Staff Report

University Avenue and Airport Road Roundabout

March 3, 2015

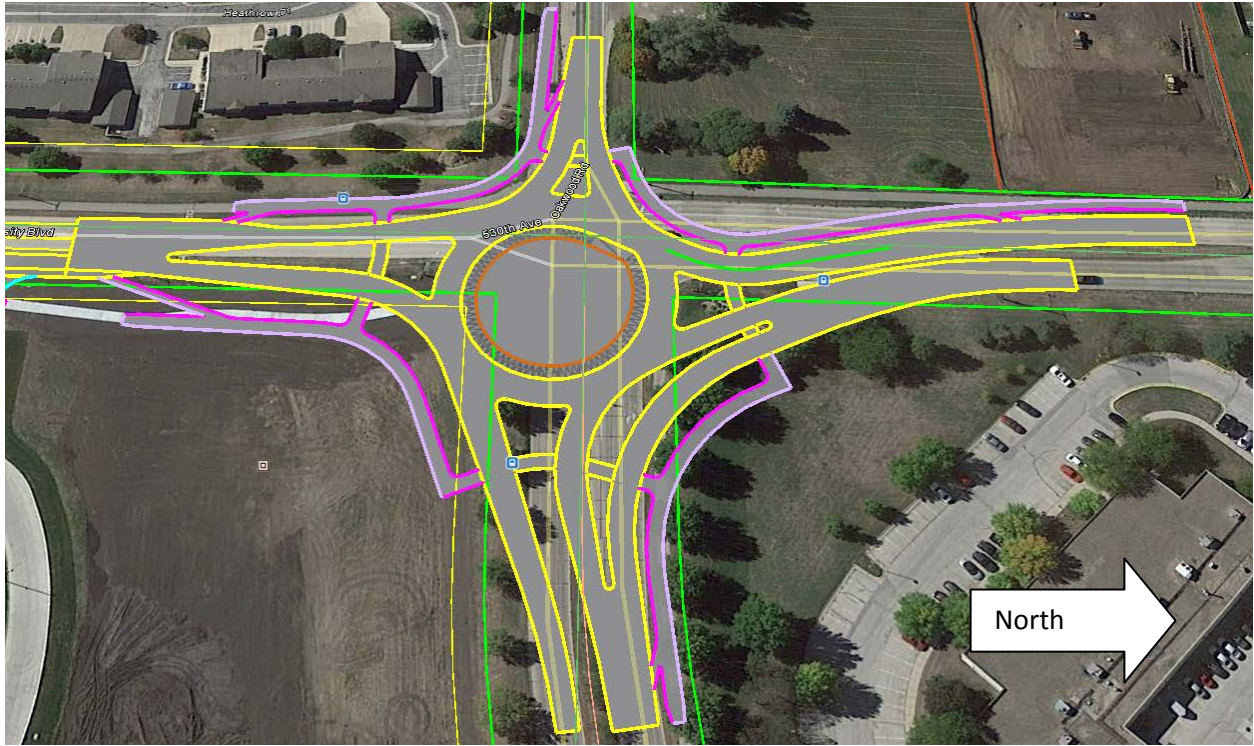
Connect to 6th Street & Campus

Please see the attached concept for the project.

The bike lanes are to be extended west on 6th Street and end just east of the existing entrance to Brookside Park. West of the entrance the street is limited on width due to the RR underpass. Any additional improvements in the area would need to be coordinated with ISU as they have jurisdiction west from the 6th Street bridge.

Attachment B1, Project Design

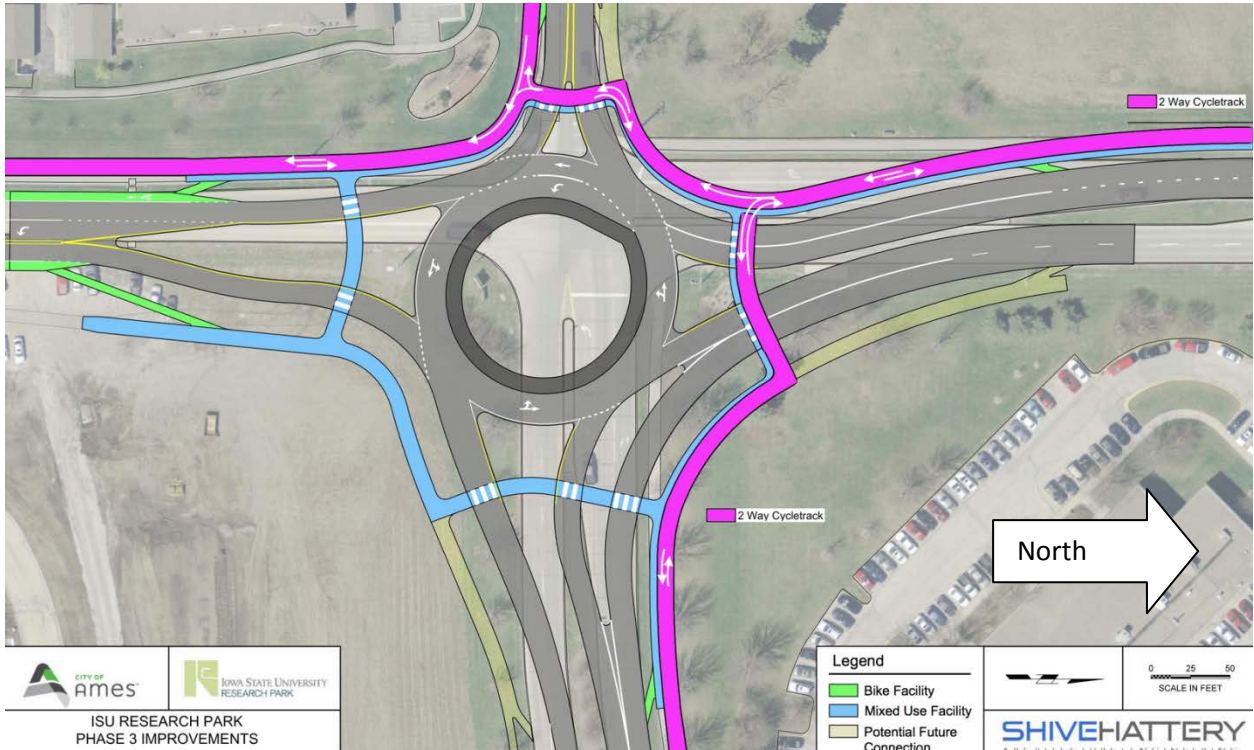
- The design team has adjusted the initial concept of five-foot sidewalks through the roundabout to 10' foot shared use paths in order to accommodate pedestrians and cyclists more easily.

- The radius at the intersections of the shared use paths street crossings were increased to 6’ in order to more easily accommodate the turning movements of cyclists. As a reference point, the standard radius on a typical residential street is 15’.

- The “splitter island” in the northeast corner was extended to provide a 6-foot pedestrian/cyclist refuge and reduce the need to cross two lanes of traffic at one time.

- Speed will be reduced in the area to 35 mph ahead of the roundabout and further reduced to 15mph through the roundabout. The current posted speeds are 45mph on University Avenue and Airport Road and 40mph on Oakwood Road.

- Vehicles will be required to yield to pedestrians and cyclists on the shared use path at all crosswalk locations. There will be significant signage and pavement markings to delineate these areas.

- With on-street bike lanes south of Airport Road along University Avenue, careful consideration was given to designing the addition of the transition ramps from the on-street lanes to the shared-use paths for those cyclists who are not comfortable navigating through the roundabouts with vehicles.
